Construction Assessment of the CMSD Landfill Cap Repair

Ormet Primary Aluminum Corporation Hannibal, Ohio

31 March 2008

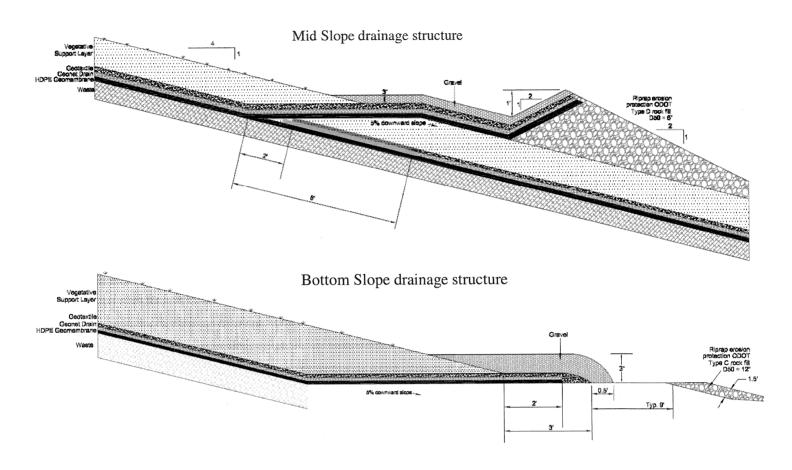
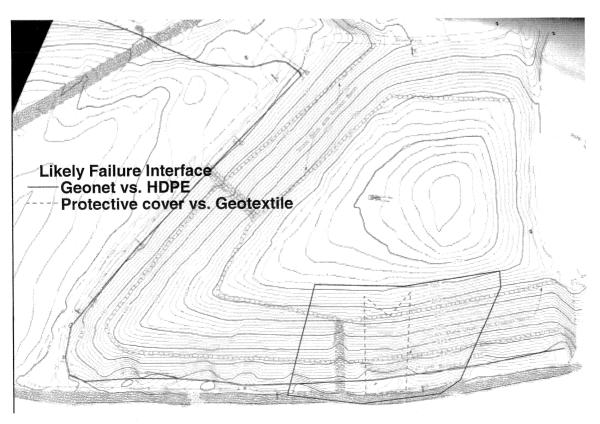
1. This report discuses the likely causes of failure as a buildup of pore water pressure in the cap drainage layer and vegetative layer. This buildup was most likely caused by excessive infiltration through cracks in the vegetative layer and insufficient drainage being provided to the geonet drainage layer. This report appears to require the installation of a mid-slope and bottom-slope drainage structure for the repaired cap drainage layer only in the area where the geonet has been completely exposed by the failure. This would leave the rest of the failed slope without proper drainage. Ohio EPA recommends installing the mid-slope and bottom-slope drainage structure along the entire riverside slope area particularly in the areas where movement has occurred.

On the following page, we have included ICF's detail drawings of their proposed midslope and bottom-slope drainage structures and the location of the observed failure.

ICF Response: The repair design includes installation of the mid-slope drainage structure along the entire riverside slope. Within the area which suffered total loss of the VSL, the upper and lower diversion berms will be reconstructed, and the upper diversion channel will incorporate the midslope drainage structure. Outside the area which suffered total loss of the VSL, the midslope drainage structure will be constructed just above the existing upper diversion berm.

The repair design calls for the construction of the bottom slope drainage structure only in the failed area. Our current understanding is that the remainder of the slope has a perimeter drainage pipe connected to the geonet. The perpendicular outlet pipes that connect to the perimeter drainage pipe have been located in the field. We will verify the existence of the perimeter drain pipe and the details of its connection to the geonet during the repair. If the perimeter drain pipe is not found during the repair, the bottom-slope drainage structure will be installed not only in the failed area but also in the unfailed area. The midslope drainage structure will reduce the amount of flow which reaches the perimeter drainage pipe. We considered the potential improvement in slope toe drainage from extending the bottom slope drainage structure along the entire riverside toe, but balancing the risk of damage to the geomembrane from excavating along the toe with the nine year history of cap stability and the reduced flow to the toe, we chose maintaining the existing drainage system as the preferred alternative in the unfailed areas.

FIGURE 2, INSET 3 CROSS SECTIONS	
Prepared for: Ormet	Scale: As shown
Date: Aug 2007	Figure 2, Inset 3
ICF International	Sheet 1 of 1

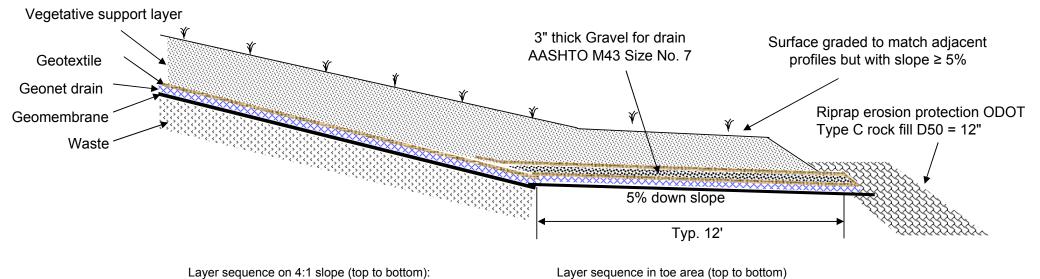
The attached drawing presents documentation of the revised design detail for the toe drain along the section undergoing repair on the south side of the Ormet CMSD landfill cap. The design revision was required due to differences between the original cap design and the actual field geometry. The toe of the geomembrane, defined as the point where the projection of the 4:1 slope of the geomembrane meets a horizontal surface at the elevation of the top of the riprap erosion protection (Elev. +630 ft. in the original design), is approximately 8 ft. closer to the river than called for in the design. In order to maintain a flat area at the toe of the slope sufficiently wide for vehicular access and to conform the geometry to match the slope profiles adjacent to the section under repair, we have increased the width of the slope toe drain and added vegetative support layer (VSL) soil above the drain.

The attached drawing supersedes Inset 3 in Figure 2, Cross Sections, dated March 2007 of the specifications package. The change has been discussed with the Kemron field representative, Mr. Stephen Poole.

This figure supersedes Inset 3 in Figure 2, Cross Sections, dated March 2007.

Plan View Toe Drain Additional Outlet Figure 1

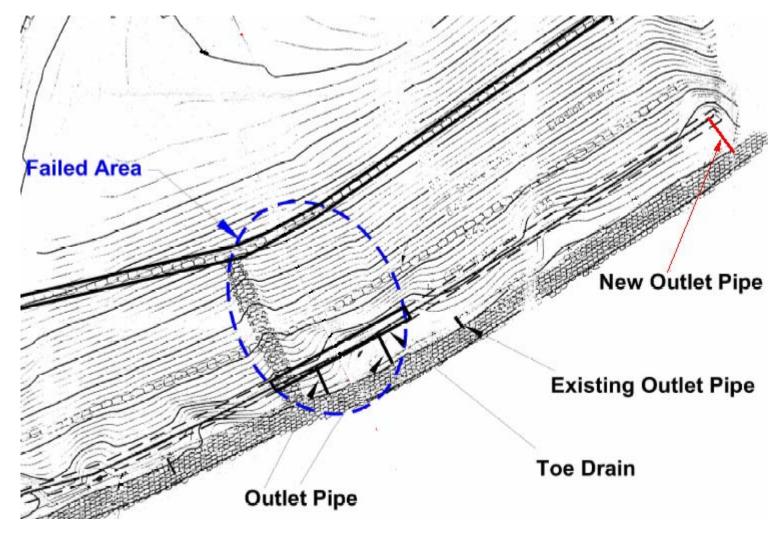
The original CMSD landfill cap construction included a 4 inch diameter corrugated plastic perimeter drain pipe along the toe of the slope with several perpendicular outlet pipes. This revision specifies the installation of an additional outlet pipe at the east end of the perimeter drain pipe along the south slope of the CMSD landfill cap. The attached drawing (Figure 1) shows the approximate location of the additional outlet.

The Contractor shall install an additional outlet pipe perpendicular to the perimeter drain pipe at the east end of the south side of the CMSD landfill cap, such that any effluent from the outlet pipe discharges beyond the toe of the slope.

The Contractor shall locate the existing perimeter pipe by excavating a trench perpendicular to the perimeter drain pipe in a location at the toe of the slope anticipated to intersect the perimeter drain pipe, taking care not to damage the existing perimeter drain pipe or geosynthetic materials. Any damage to the geomembrane shall be repaired at no cost to the Owner. The Contractor shall make the initial trial excavation approximately 30 feet west of the east end of the slope. If the perimeter drain pipe does not exist at that location, the Contractor shall make additional trial excavations each 20 feet west of the previous excavation until the perimeter drain pipe is located.

The additional outlet pipe shall be connected to the perimeter drain pipe with an elbow, if the excavation intersects the end of the existing perimeter drain pipe, or with a tee, if the trench intersects the existing perimeter drain pipe elsewhere.
